Loughor-Gowerton Cycleway (NCN Route 4) Options Report – a summary.

This is a summary of the report titled as above which was prepared by Arcadis (A Cardiff Design Consultant.) for Swansea Council. It is dated November 2019. The report provides options for improving NCR 4 from Loughor Bridge to Pont-y-Cob Road inclusive. This summary focuses on the options preferred in the report. It ends with some comments.

Existing NCR 4 (D & 4) and report's preferred route (E- G). X = Avon Lliw bridge (F)

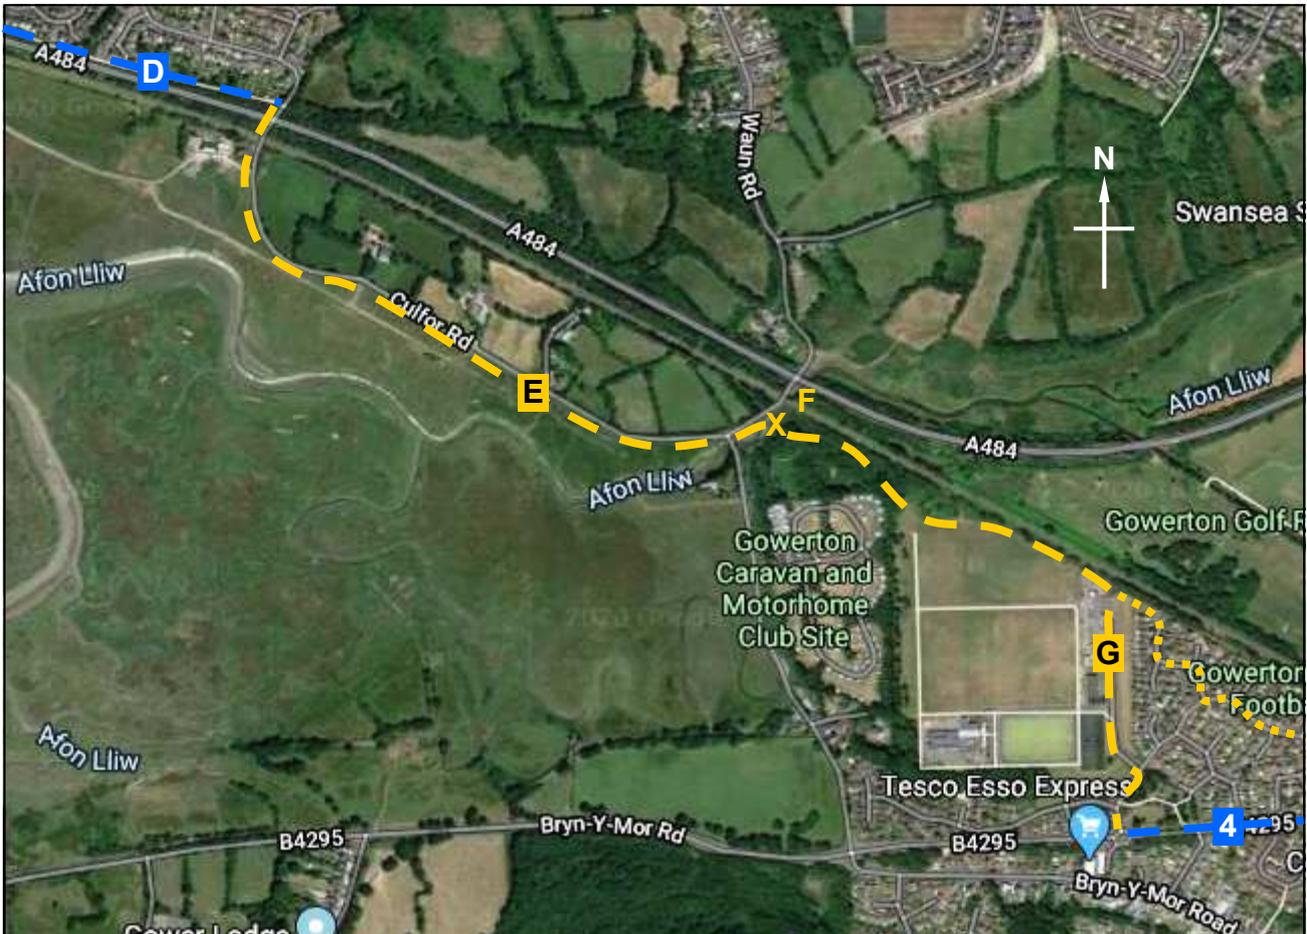
Wheelrights are pleased that the preferred options for sections B, C and G reflect their aspirations. B and C having already been implemented they hope that G will too. They also support E but are aware that the preferred option A would be relatively expensive. If Culfor Road were made one way E-W, as *Wheelrights have proposed*, option B would make sense. It would be a lot cheaper than A. In the event that the preferred option (A) for section G goes ahead and E is deferred, the route through G should be designed so that it would link with a future route through E. This implies a crossing of Pont-y-Cob Road on the north side of the Island Bridge and a new cycle-pedestrian bridge over the Avon Lliw at X.

A variation on the section G route, shown by the yellow dotted line, may be preferred as it is slightly more direct. It would join the existing NCR 4 on the B4295 at the east end of Ffordd Beck rather than the west. The streets it goes through being residential could be designated "quiet streets" (or possibly "cycle streets") as are Station Road and Ferndale Drive in the report.
